SERVICE PROCEDURE

G-05514-R2
February 2006

**SUBJECT: SAFETY RECALL (U.S., EXPORT)
BATTERY CABLES on 9000 models built 4/1/2002
thru 6/15/2005**

REVISION DESCRIPTION

Figure 2 – Saddle Clamp Installation REQUIRED

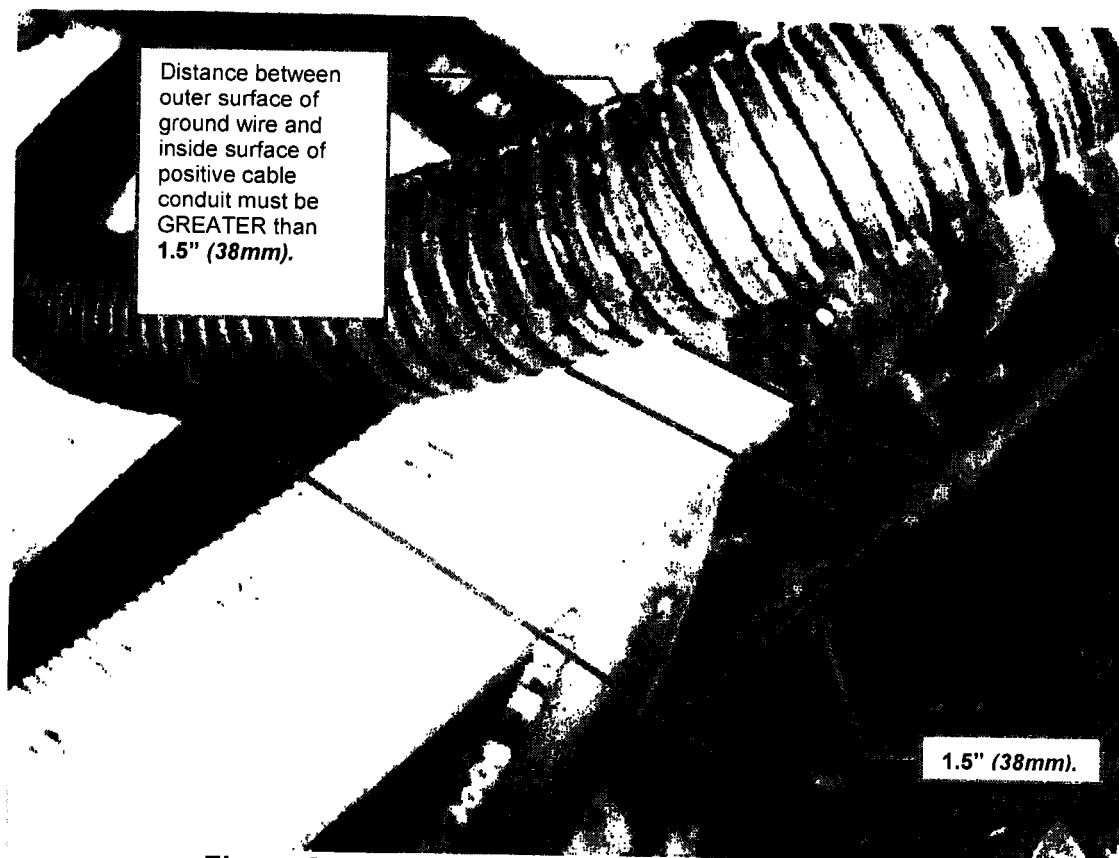
- Added the FINAL INSPECTION to the ***INSPECTION/REPLACEMENT PROCEDURE TABLE.***
- Modified Step 5.
- Added **NOTE** below ***SADDLE CLAMP INSTALLATION.***
- Modified ***Caterpillar® Engine Warning***
 - Added **NOTE** below Figure 7.
 - Re-worded clocking step.
- Added **Figure 8a.**
- Added ***FINAL INSPECTION.***

5. If the smallest gap is 1.5 inches (38mm) or LARGER, then no saddle clamp installation is necessary, skip to **FINAL INSPECTION**.

**Figure 7 --
Chafing may occur between Engine Block Ground and Newly Located Positive cables.**

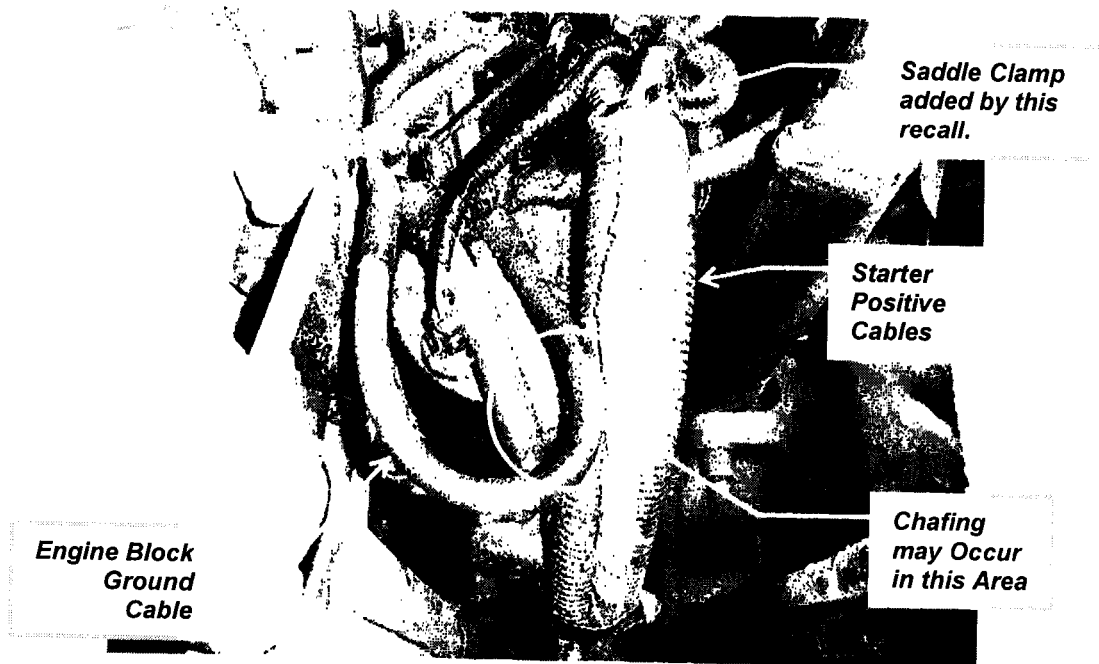
NOTE: If NO rubbing or chafing is present between CAT ENGINE GROUND cable and battery cables, NO re-clocking is necessary.

- ***If rubbing or chafing of the ENGINE GROUND cable against the Battery Cables is present***, rotate and tighten the new ground cable on the starter terminal so it is straight down (6 o'clock position) and *not* contacting the starter positive cables, see figure 8.
